STATE OF MAINE
DEPARTMENT OF TRANSPORTATION
16 STATE HOUSE STATION
AUGUSTA, MAINE 04333-0016

July 10, 2025
Subject: Woodland Fish Passage
WIN: PH20250514WFP
Location: **Baileyville**
Amendment No. 7

REMOVE, "Exhibit B-6 Intake Rack Design for Downstream Passage" 90% design plans by Kleinschmidt dated June 3, 2025, and **REPLACE** with the attached "Exhibit B-6 Intake Rack Design for Downstream Passage" Issued for Bid and dated July 9, 2025.

REMOVE, select sheets of "Exhibit B Design Plans" and dated June 3, 2025, and **REPLACE** with the attached revised sheets of "Exhibit B Design Plans" dated July 9, 2025. Revised sheets are listed in the Drawing Updates table below, and updates are clouded for visibility.

SITE PLAN
SCALE: 1"=150'

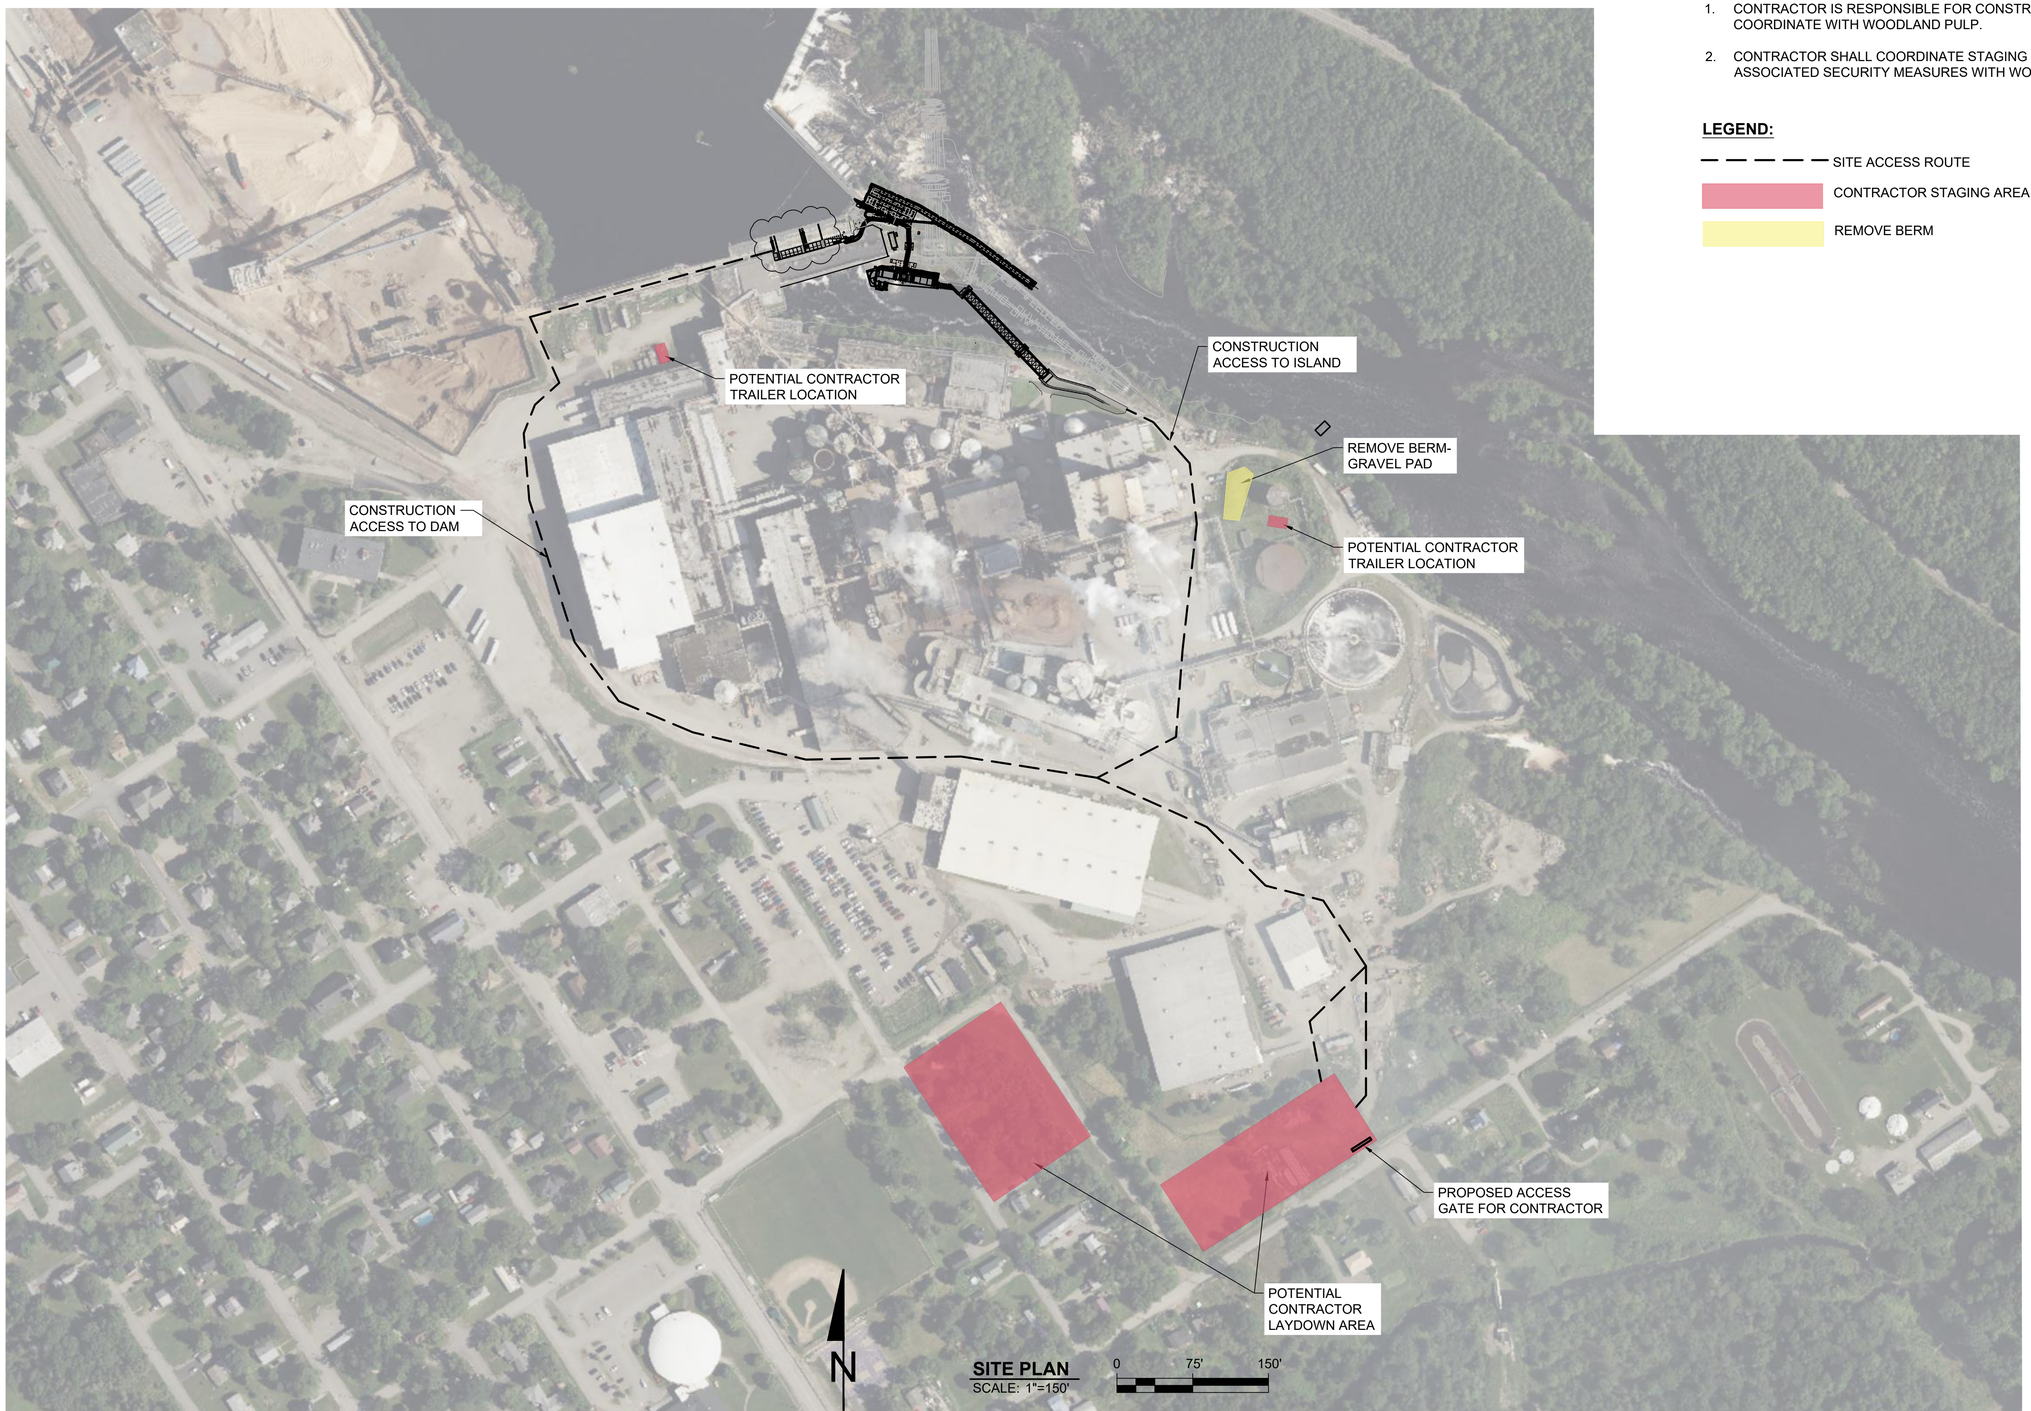
74. **Question:** Drawing G-121 shows removal of berm. At the site visit it was unclear whether the material was contaminated or not. Please clarify. Also does is it the intent for the berm to be rebuilt?

ABOVE GRADE RACEWAY PLAN - FISH LIFT PASSAGE SITE (1)

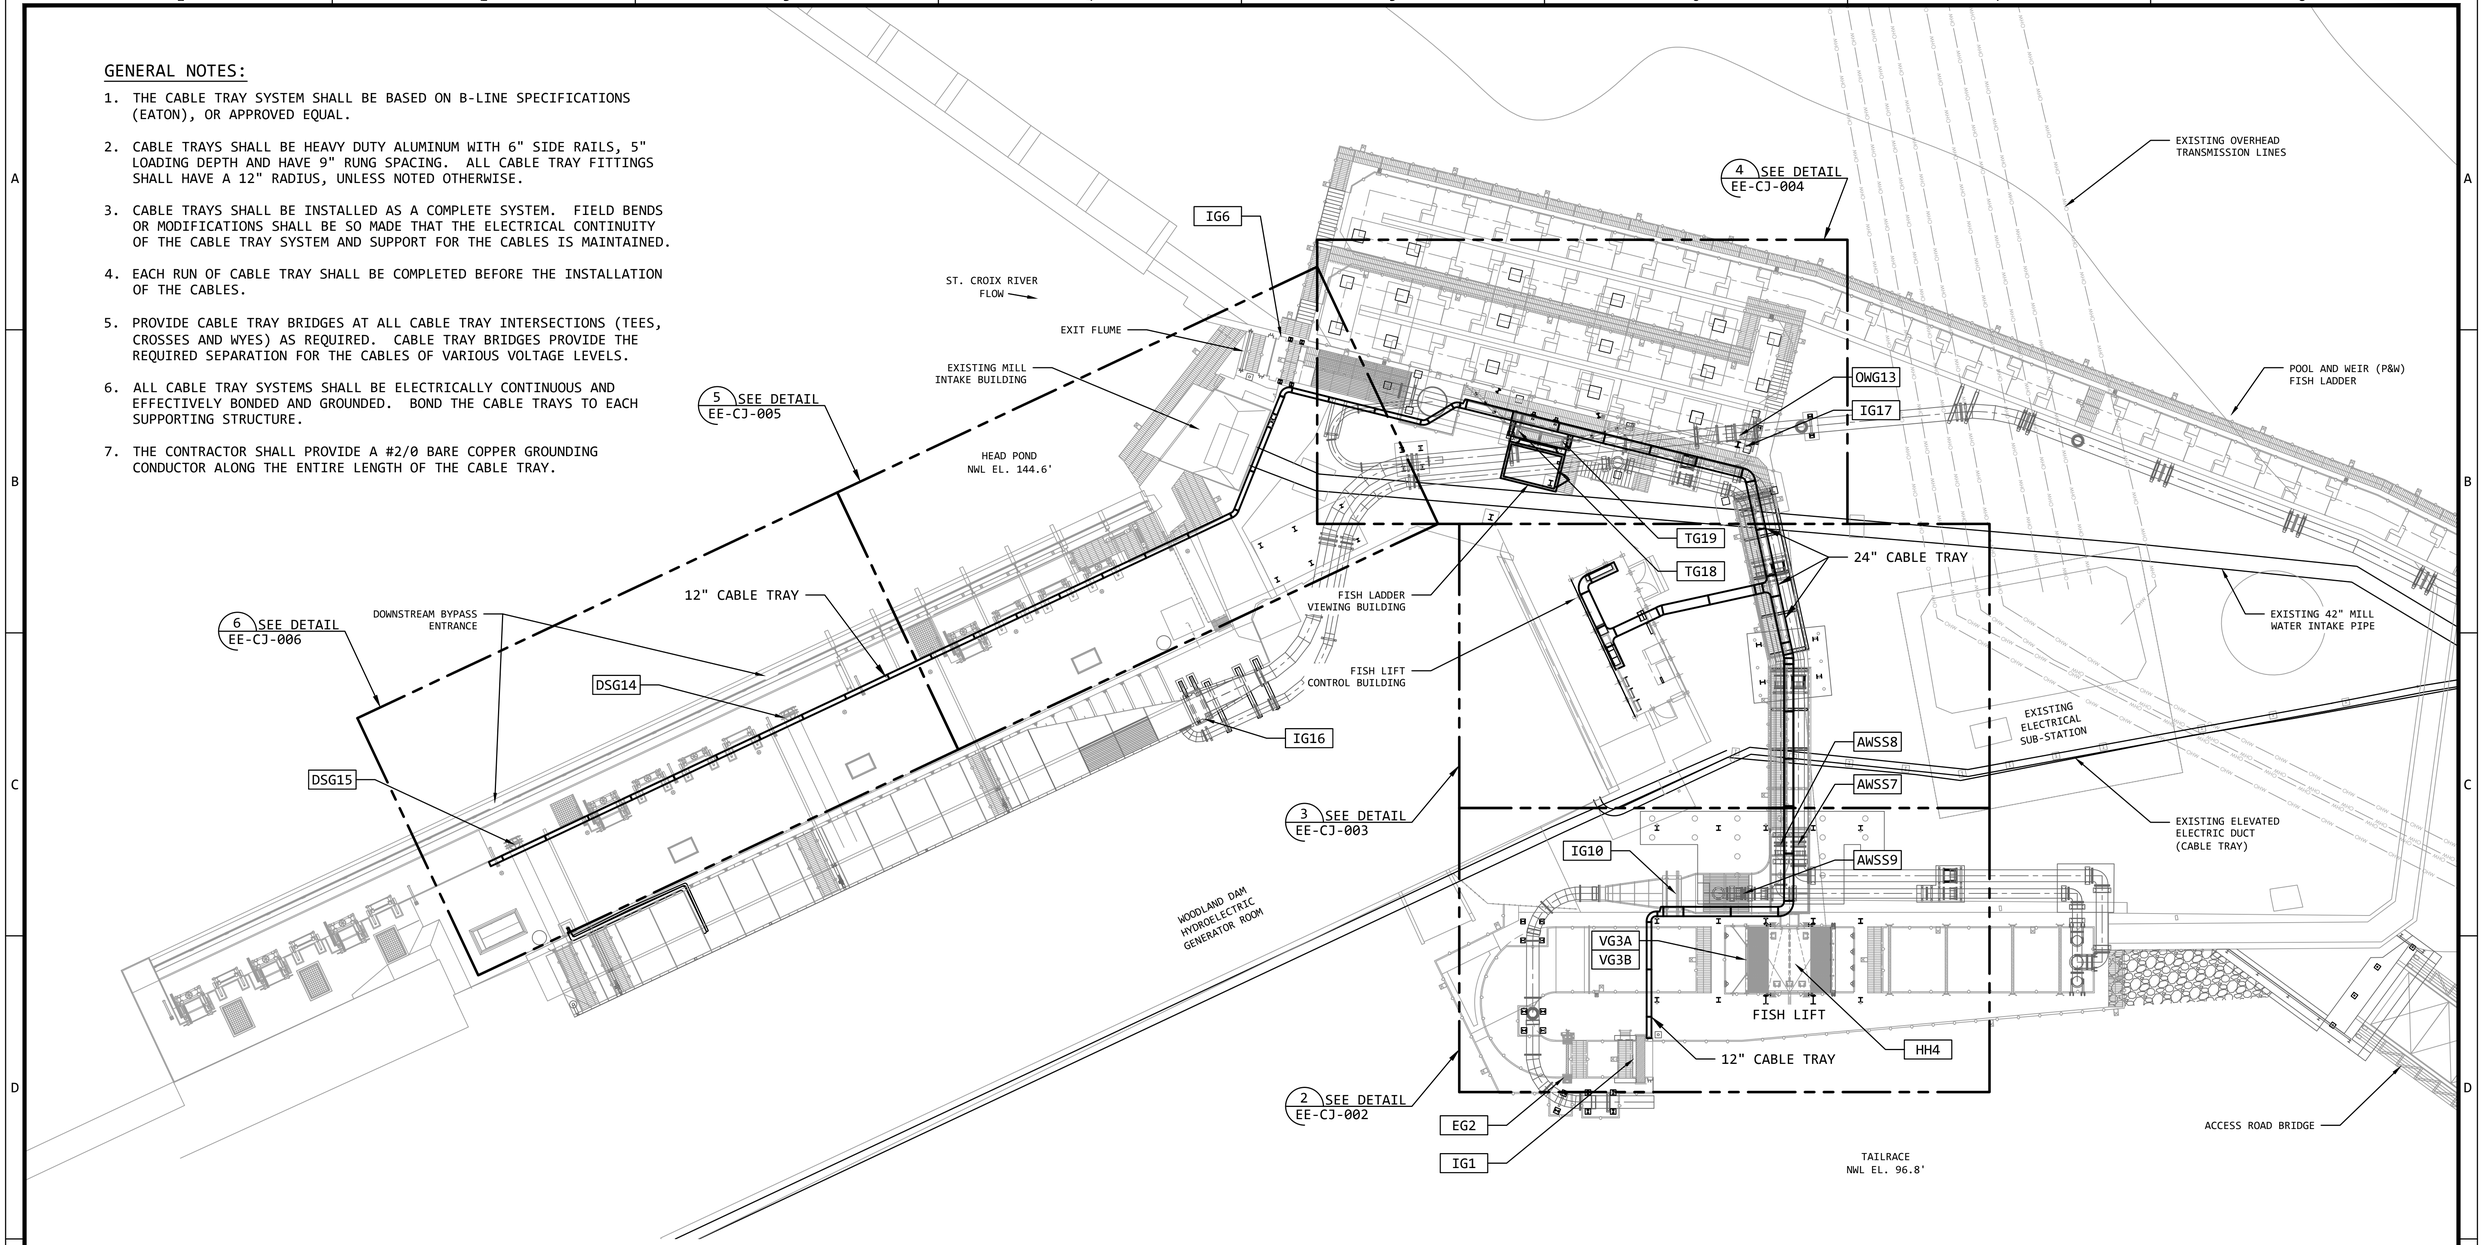
53. **Question:** Please provide a tray cable specification.

Response: The cable tray specification is found in the general notes on Sheet EE-CJ-001. Notes 1 and 2 refer to the material, and Notes 3 through 7 refer to installation. See the enclosed WPLLC Tray Installation Specifications Section for further details on which the electrical design was based.
